NW Bicester

Environmental Statement Addendum, April 2011

Bicester Eco Development

Exemplar Environmental Statement Addendum

Figure 3-2 Post-development extent comparison

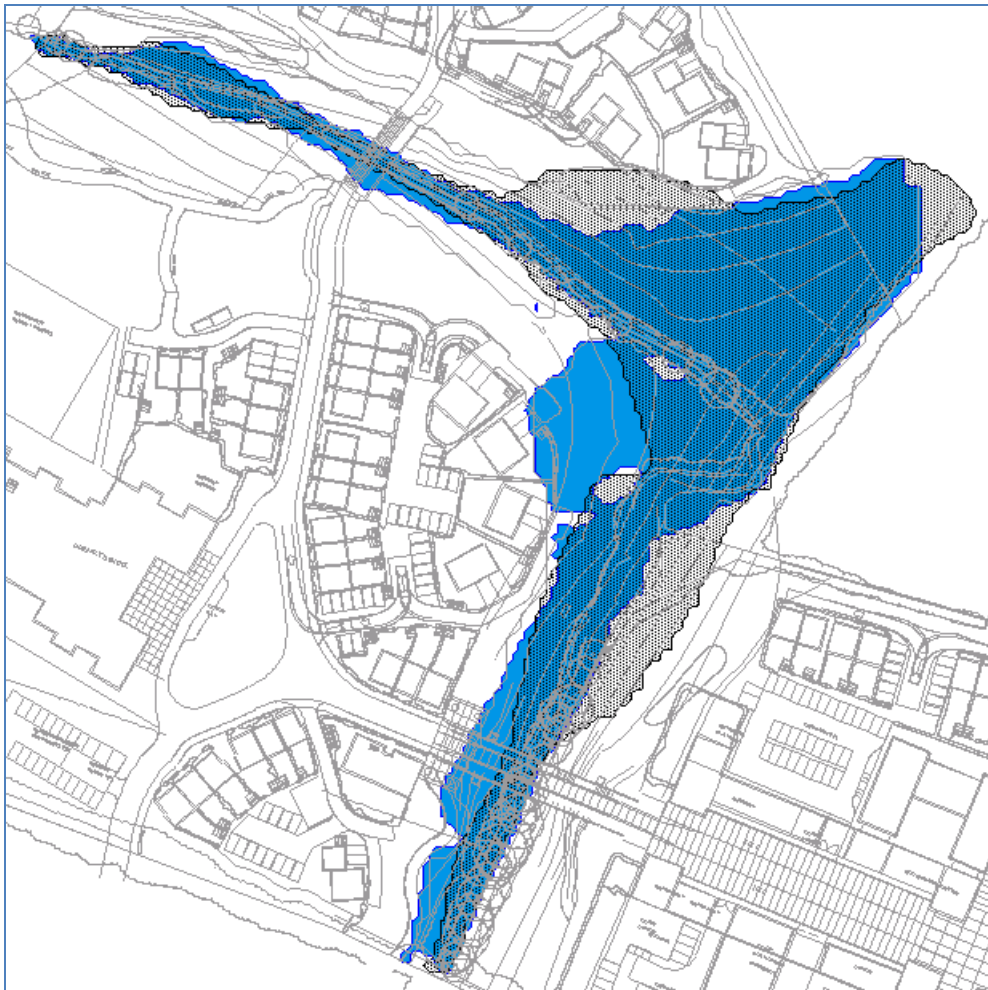
Figure 3-2 shows the change in flood extent caused by the proposed development for the 1000-year flood event (i.e. Flood Zone 2), where the revised baseline is shown in blue and the post-development extent in black.

This shows that around the proposed bridge on the tributary, the contouring and bridge structure have little impact on the modelled flood extents. Downstream of this area, the re-contouring causes additional flooding on the open space on the left bank, but this does not threaten the proposed development. At the confluence with the River Bure, the re-contouring has significantly reduced the flood extent on the western side of the confluence, removing the area of flooding that impacts the gardens and roads from the revised development masterplan. Downstream of this area, the landscaping associated with the second bridge has decreased the flood extent at the bridge location downstream, but increased the flood extent upstream of the bridge on the left bank of the River Bure. This also does not threaten the proposed development.

Project	BICESTER ECO DEVELOPMENT ENVIRONMENTAL STATEMENT
Title	EXEMPLAR LAYOUT SHEET 1 OF 2 DRAWING 3-1

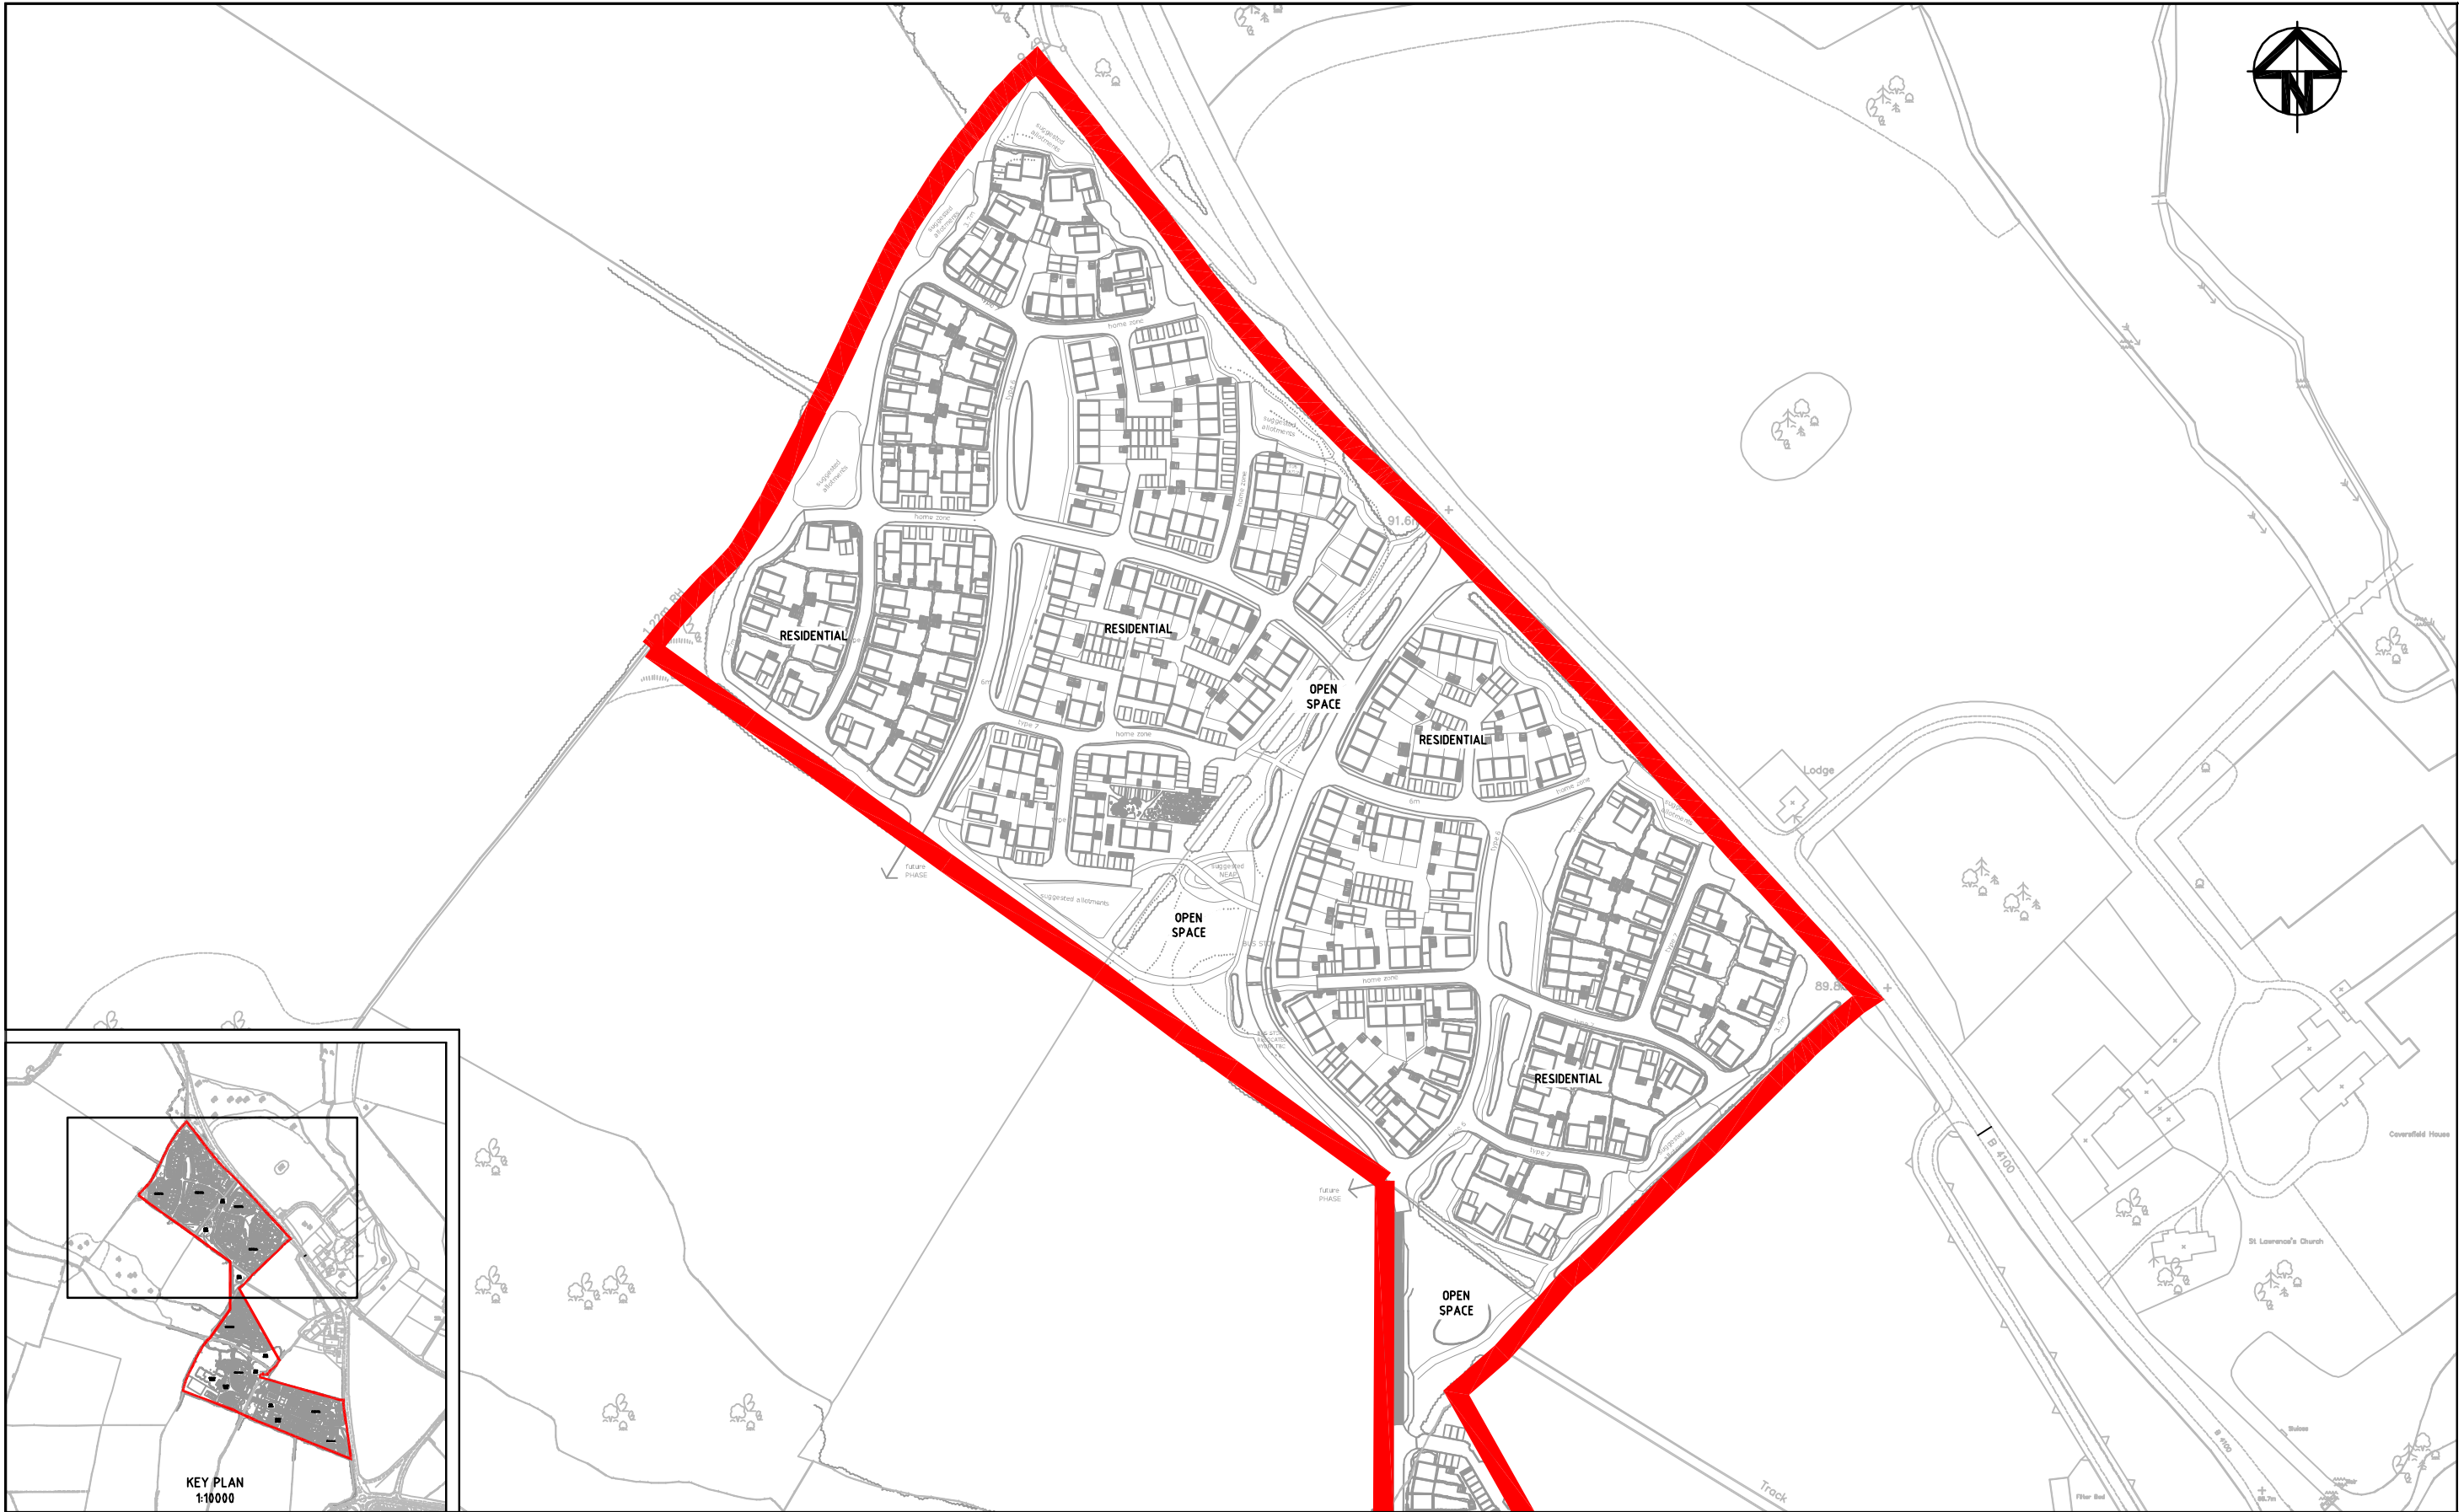
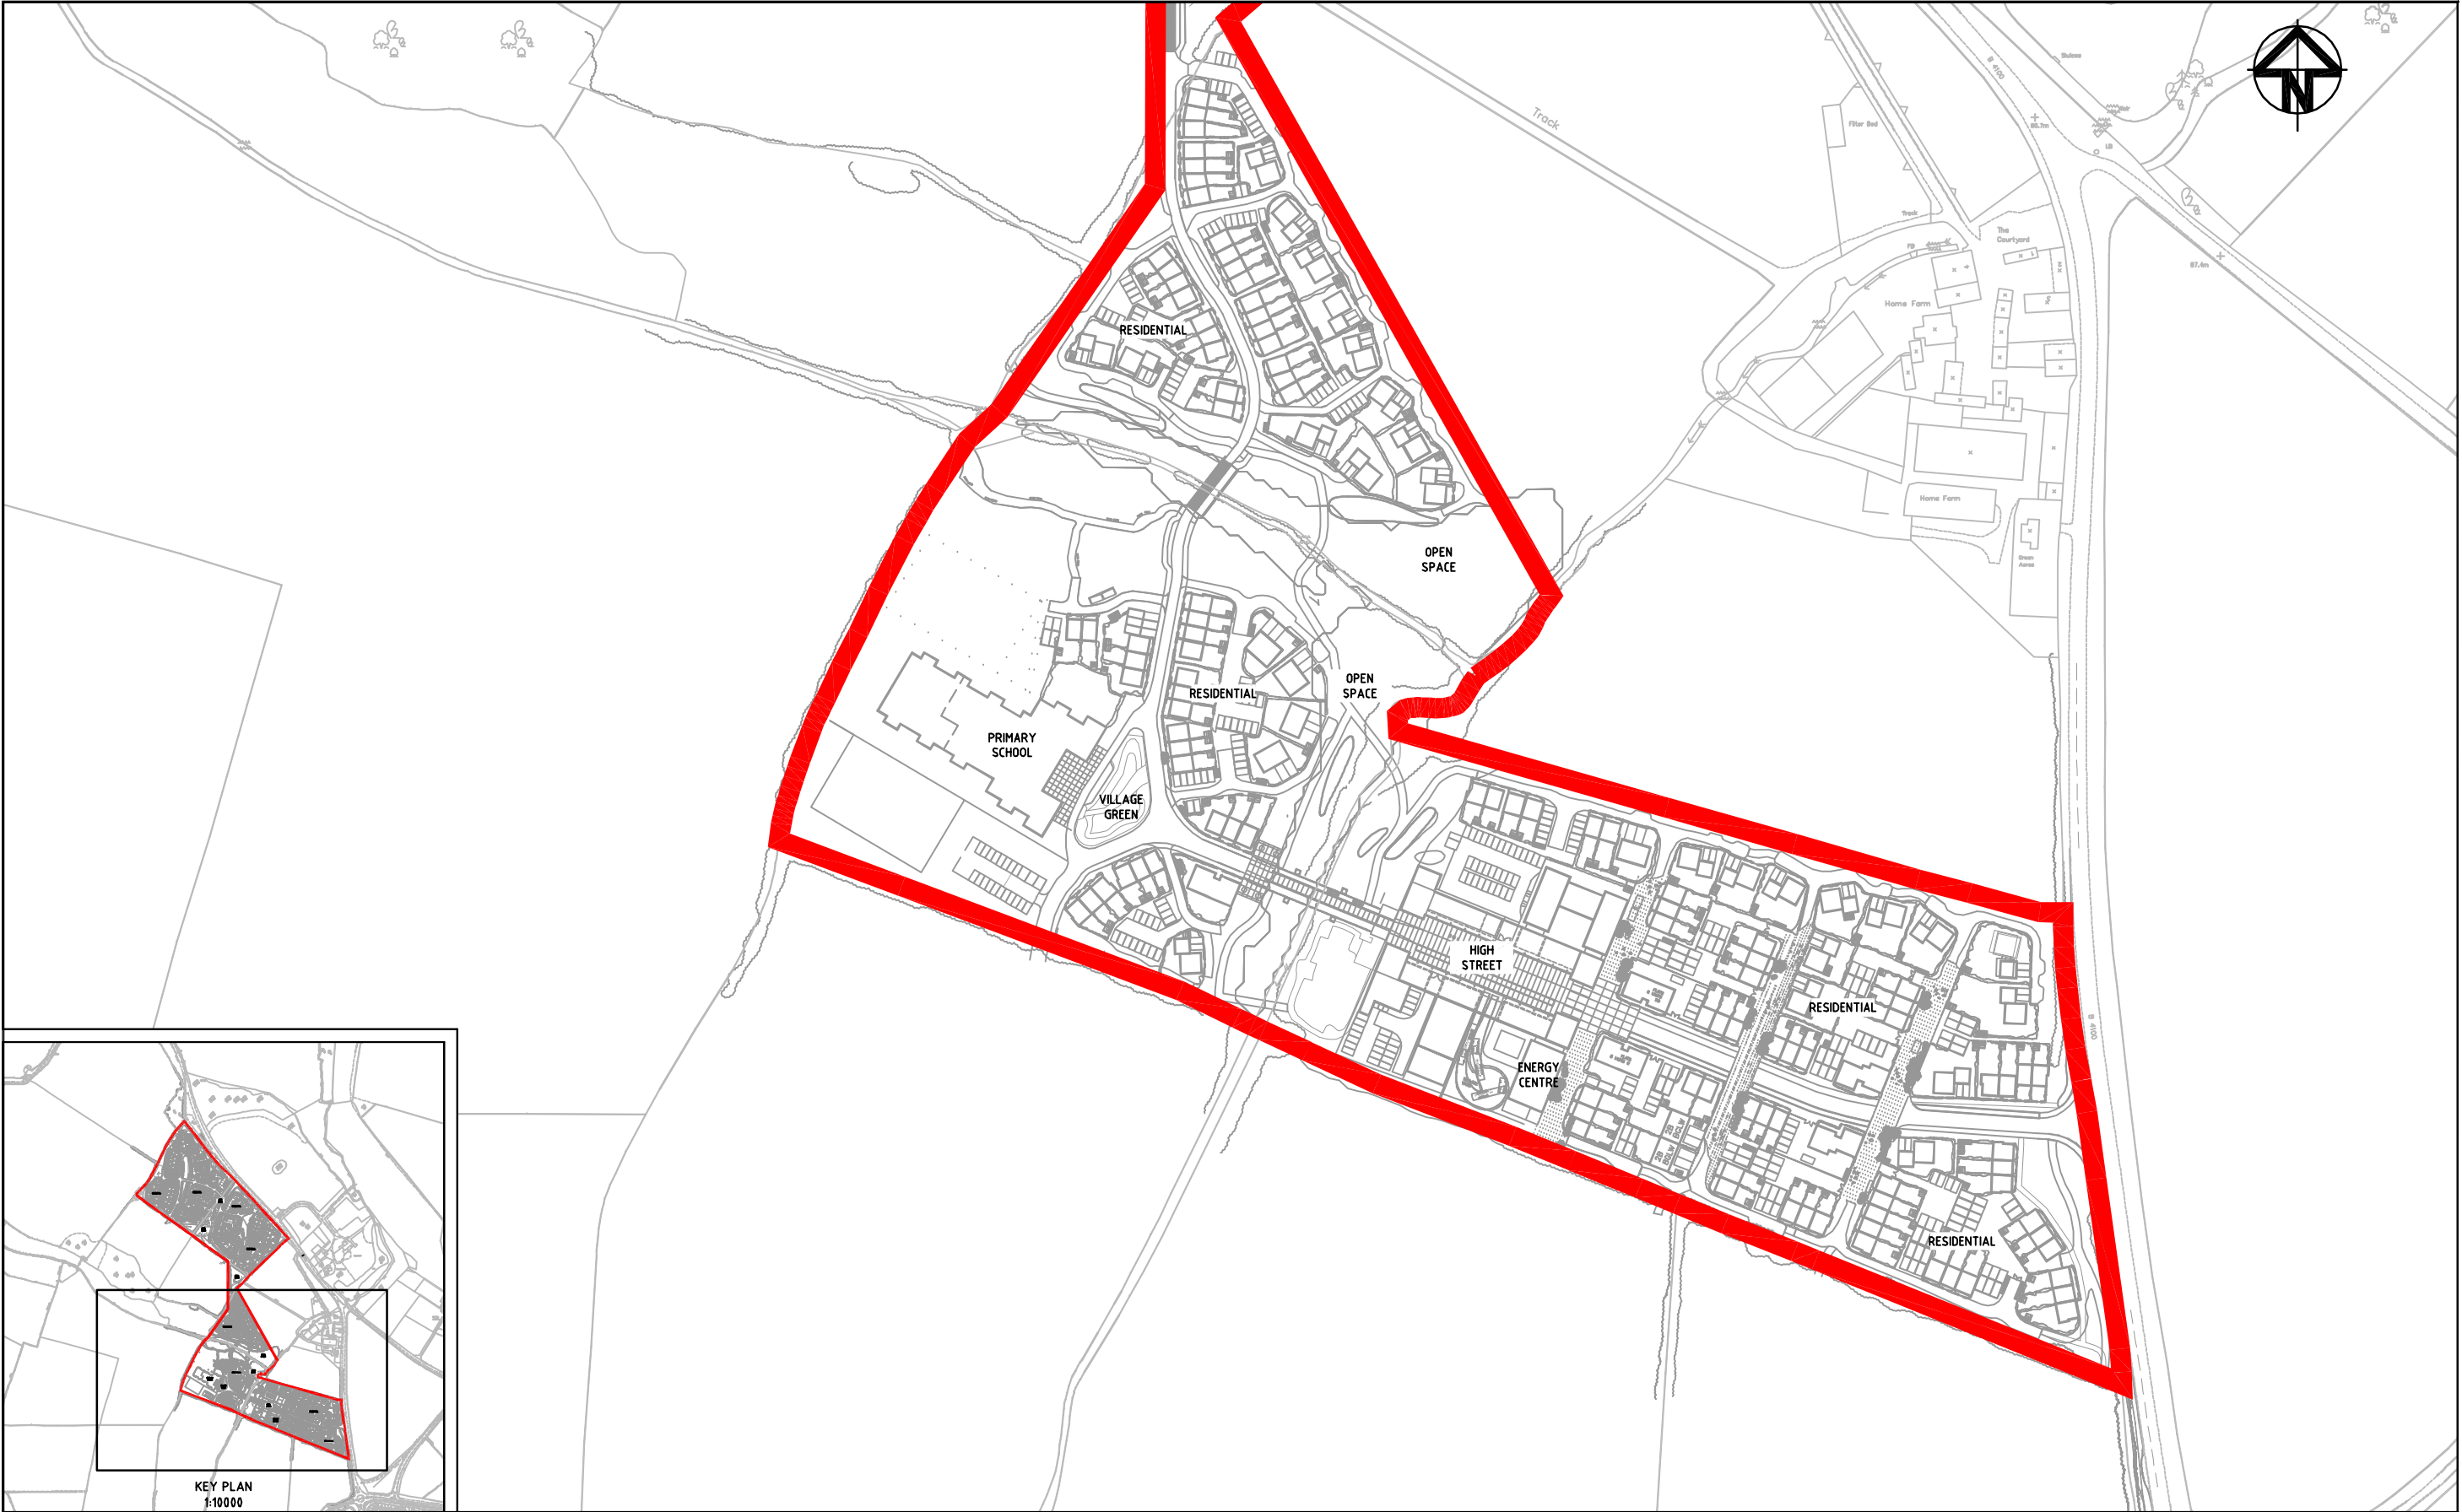
The updated exemplar layout is shown in revised Drawing 3-1. The revisions to the exemplar layout retain the same site area, housing numbers, mix, and designs as the original application and the broad distribution of houses within the three areas, north, central and south remain the same as previous layout. The non residential uses are also the same and the location in the south along a village high street with potential future connections to further phases remains the same. The parking provision overall has been reduced from the original application, with the larger dwellings having fewer on plot parking spaces and the smaller dwellings having the flexibility to have one unallocated parking space. The larger houses have therefore been provided with additional ground floor home working or storage space within the original attached garage space. The unattached garages in the parking courts have been increased in size and have all been provided with green roofs.

The revised north fields layout has enabled the foot and cycle paths to realigned to create the most direct connections between through the housing in the north fields directly towards the village centre rather than the previous grid pattern of connections which forced the walking route against natural desire lines.

The revised layout also provides additional large areas of green open space in the centre of the housing. Whereas the original application had two types of residential character: a perimeter hedgerows facing house type and a inner street house type, the new layout creates more distinctive character areas using wider open green spaces with frontage housing within the residential areas to break up the plots and repetition and to enable better orientation for residents. The size of the perimeter blocks has been increased which allows the creation of longer terraces of houses which provides a sense of enclosure fronting the spaces and a more flexible layout to create different areas of rear parking courtyards.

The perimeter landscape between the housing and the hedgerows has been revised and the housing perimeter is no longer parallel to the hedgerows which creates a more varied width of buffer to assist the new habitat creation and amenity uses in the landscape.

The hierarchy of access is also revised from the original application so that within the housing area there is less repetition of similar street design and a more gradual hierarchy established from spine road to access lane to perimeter lanes and paths. The layout gradually opens a

The connecting route between the north and central fields has been changed from the previous layout which had an all vehicle access road. The revised layout has connections between the north fields and the central area by footpath and cycle and vehicular access only for bus, taxi, emergency and refuse vehicles. This revised layout will significantly shorten the distance travelled to access the village centre, school and shop using alternative modes of transport to the private car.

The revised north fields layout also differs from the previous design by providing a spatial framework which has a potential to link the North fields through to the future development of two fields to the south. Both access and green open spaces are now designed to be extended south creating potential green corridors for biodiversity and connectivity for residential areas.

The bus route has been changed as a one way route picking up passengers in the north fields with the bus route travelling south to the village centre before returning to Banbury Rd. A temporary bus stop has been added in the village centre. An additional bus stop has been located on the Banbury road at the south entrance to allow people to use buses travelling further villages to drop off or pick up.
